# UNITED STATES PATENT AND TRADEMARK OFFICE

APPLICATION NO.	FILING DATE	FIRST NAMED INVENTOR	ATTORNEY DOCKET NO.	CONFIRMATION NO.
10/767,744	01/30/2004	Christian Bauer	713-1004	5715
33712	7590	04/17/2006	EXAMINER	
LOWE, HAUPTMAN, GILMAN & BERNER, LLP (ITW) 1700 DIAGONAL ROAD SUITE 300 ALEXANDRIA, VA 22314			WUJCIAK, ALFRED J	
			ART UNIT	PAPER NUMBER
			3632

This is the final Office Action for the serial number 10/767,744, RETAINING MEMBER, filed on 1/30/04.

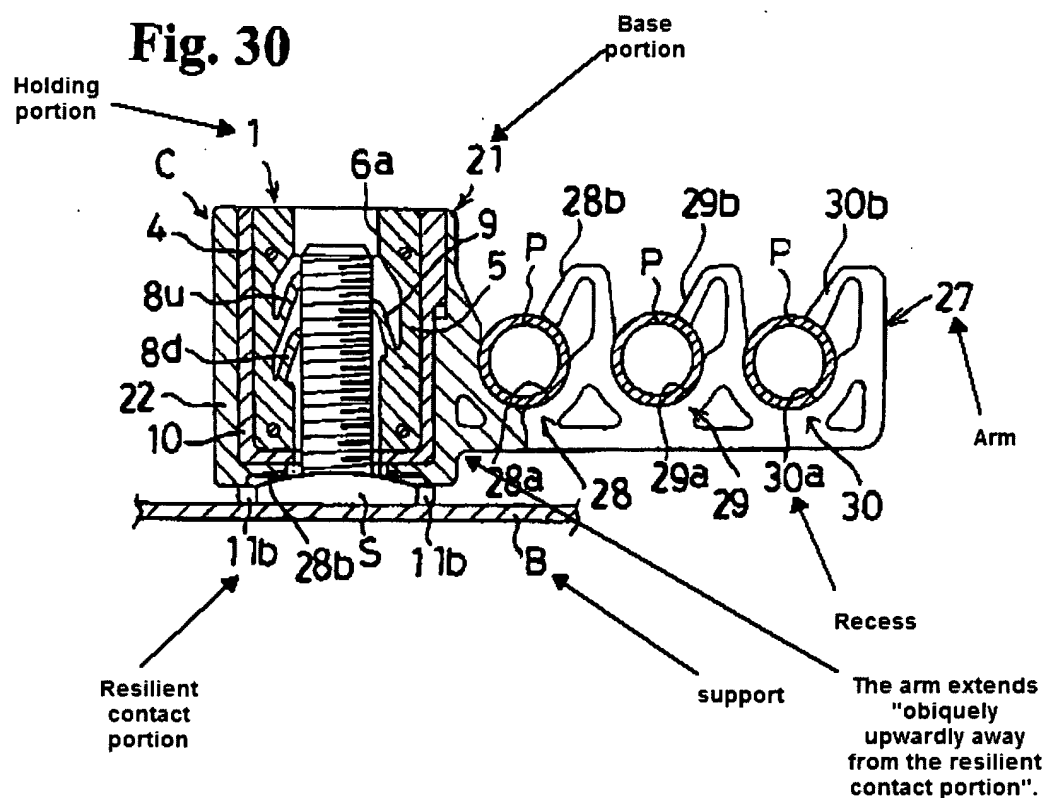
With respect to applicant argument on page 8 stating that “Miura, clearly fail to teach or suggest that the arm extends laterally away from said base portion and obliquely upwardly away from said resilient contact portion”. The examiner disagrees with the applicant because the arm (27) is clearly extending laterally away from the base portion (21) and the arm extends “obliquely upwardly away from the resilient contact portion (11b)”. The resilient contact portion is located below the base portion and the arm is above the resilient contact portion and extending away from it.
